Issue List

NCANG Repair Bldg 51 (Charlotte, NC)

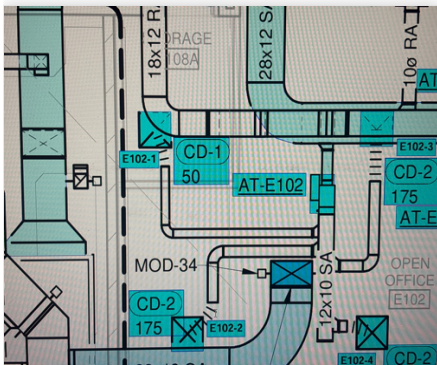
Issue Name : VAV AT-E102 Missing Diffuser
Description : Diffuser E102-1 is missing in room STORAGE 108A
Created By : National TAB **Assigned To :** National TAB - Antonio Flores-De La Cruz
Status : Open
Priority : **Asset Tag :**
Originated Date : 01/21/2026 - Antonio Flores-De La Cruz - National TAB

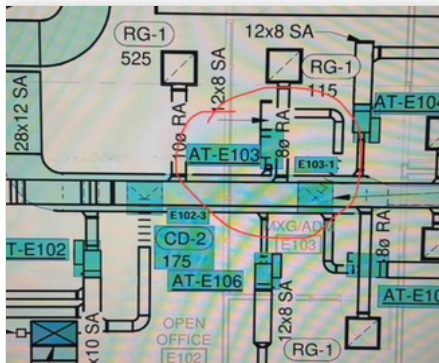
Issue Name : VAV AT-E103 Wrong Location
Description : VAV AT-E103 is installed in the wrong location per the drawings. It should have been installed in MXG/ADM E103 but instead was installed in room OPEN OFFICE E102. A diffuser is installed in room E103, but it is connected to VAV AT-E101, which is incorrect.

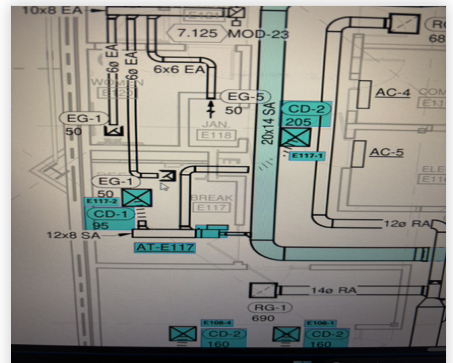
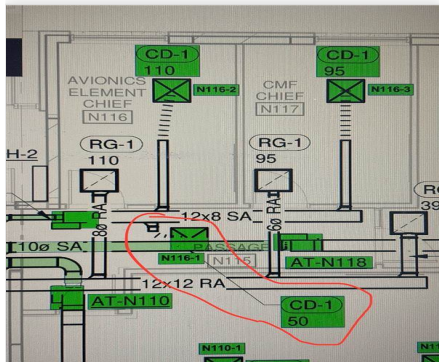
Issue Name : VAV AT-E117 Missing Grille
Description : Diffuser E117-1 in CORRIDOR E115 is missing. Upon inspection, it appears that the duct is attached to the VAV but it stops at the brick wall of room BREAK E117 and doesn't penetrate to the other side.
Created By : National TAB **Assigned To :** National TAB - Antonio Flores-De La Cruz
Status : Open
Priority : **Asset Tag :**
Originated Date : 01/21/2026 - Antonio Flores-De La Cruz - National TAB

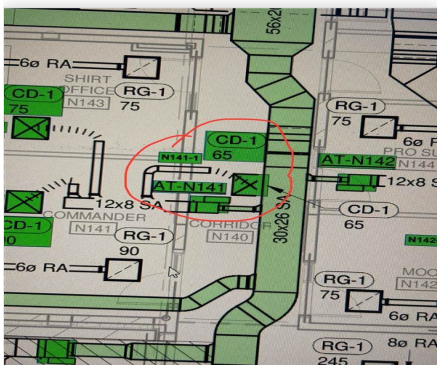
Issue Name : VAV AT-N141 Missing Diffuser
Description : Diffuser in Corridor N140 (N141-1) is missing.
Created By : National TAB **Assigned To :** National TAB - Antonio Flores-De La Cruz
Status : Open
Priority : **Urgent** **Asset Tag :**
Originated Date : 11/11/2025 - Antonio Flores-De La Cruz - National TAB

- **01/21/2026 National TAB - Antonio Flores-De La Cruz**
 - SAW MECHANICAL CONTRACTOR FIXING ISSUE, WILL CHECK
- **11/12/2025 National TAB - Antonio Flores-De La Cruz**
 - Diffuser was installed, but after attempting to balance, the supply grille in Shirt Office N143 (N141-2) is swapped with the grille for the return. It must be swapped.
